ARCHITECTURAL REVIEW BOARD MEETING

APRIL 9, 2024 IN THE CITY COUNCIL CONFERENCE ROOM AT 5:00 PM

PLANNING AND ZONING COMMISSION MEMORANDUM

CASE NUMBER: SP2024-011; *Amended Site Plan for 1220 Data Drive*

EXHIBIT 1. ABOVE GROUND STORAGE TANKS REQUIRE A SCREENING WALL THAT MATCHES THE MAIN STRUCTURE AND COMPLETELY SCREENS THE ABOVE GROUND STORAGE TANK FROM VIEW. IN ADDITION, LANDSCAPE SCREENING SHOULD BE PROVIDED.

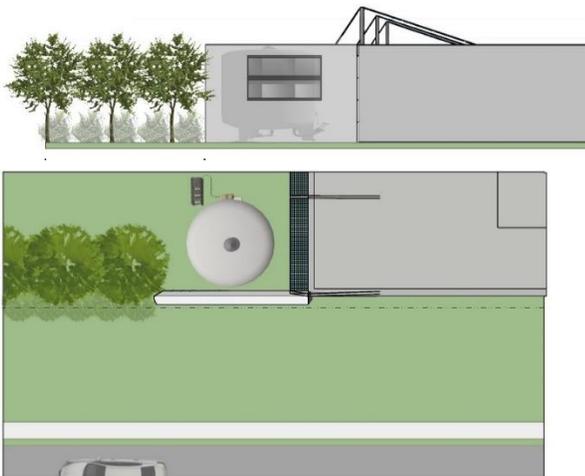
height of the wing wall to match the height of the building (i.e. 39.5-feet) in conformance with the requirements of the Unified Development Code (UDC), and [2] provide the landscaping as described in staff's comments. The applicant has chosen not to incorporate any of the Architectural Review Board (ARB) or staff's recommendations into the proposed plans.

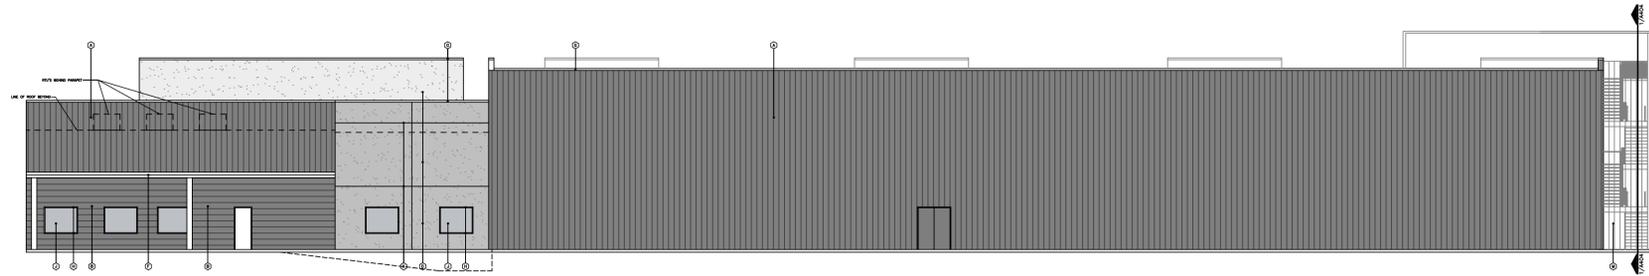
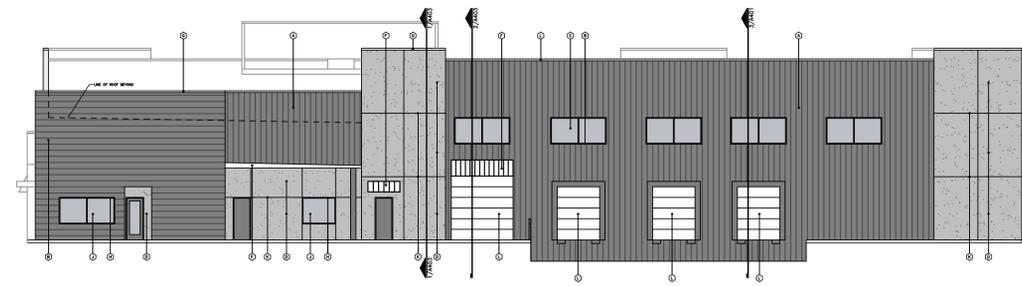
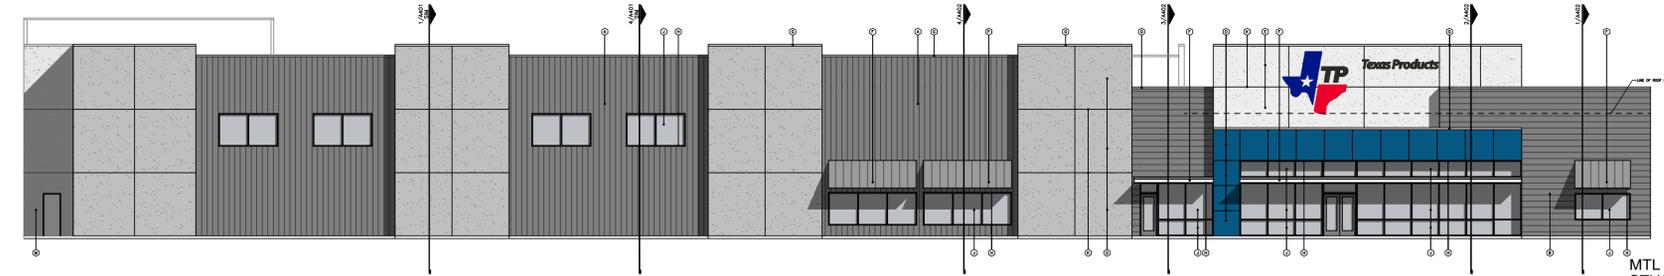
On March 26, 2024 the Architecture Review Board reviewed the proposed building elevations provided by the applicant and recommended that the applicant [1] internalize the fire escape, [2] project the stucco elements out, and [3] extend the parapets back and finish the back side of the parapets in the same material as the exterior facing façade. The applicant has provided updated elevations that will be reviewed by the Architectural Review Board (ARB) prior to the April 9, 2024 Planning and Zoning Commission meeting.

We are requesting an exception to the vertical and horizontal offset projections. This project does provide a small percentage of articulation with vertical and horizontal projections. The entry area has a raised stucco entry tower and a metal covered canopy stretching outward across the large storefront and projects outward. The stair tower on the west side also gives a vertical projection. We are providing what the ARB requested by projecting the large stucco vertical elements outward 1'-0" and back over the roof 1'-0" to create a thicker element.
